## Checking Surface Wear on the Front Brake Caliper Connection Hose

Multistrada 1200 MY 2010-2014 (all versions)

Service Repair Bulletin SRV-SRB-23-040

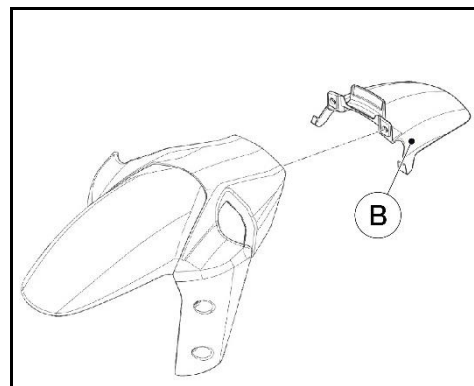
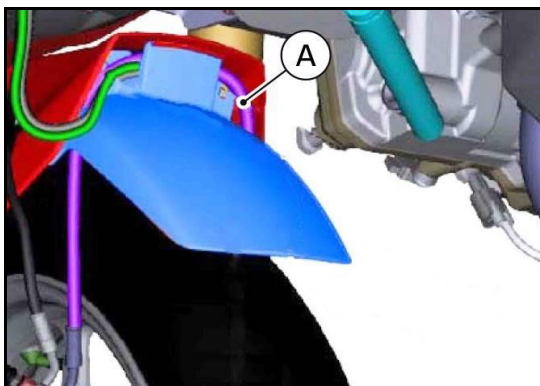
Due to possible unknown service history of the vehicles listed above, we ask you, on all models in question, during each Annual Service and Oil Service, to check the surface wear status of the sheath on **Brake Hose (A) connecting the front brake calipers**.

If wear is found, the hose in question must be replaced.

We also ask you to pay special attention during positioning of the above-mentioned brake hose during all the operations involving removal and subsequent refitting of **Front Mudguard Extension (B)**. For any further details about the assembly instructions of the extension, refer to the specific bulletin [SRV-SRB-19-027](#) ([link ↗](#)).

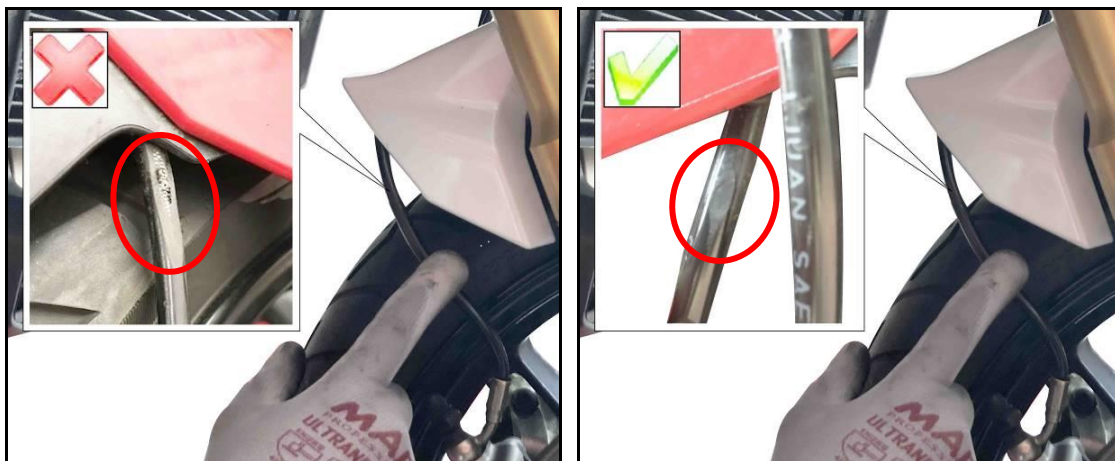
The additional visual inspection of possible wear on front brake caliper connection hose is required at the two areas shown in the figure:

The visual inspection must be carried out regardless of whether the front mudguard extension is present or not.

To check for possible wear on the brake hose connecting the front brake calipers, the hose must be moved as shown in the figure:

### 1. Vehicle left-hand side

### 2. Vehicle right-hand side
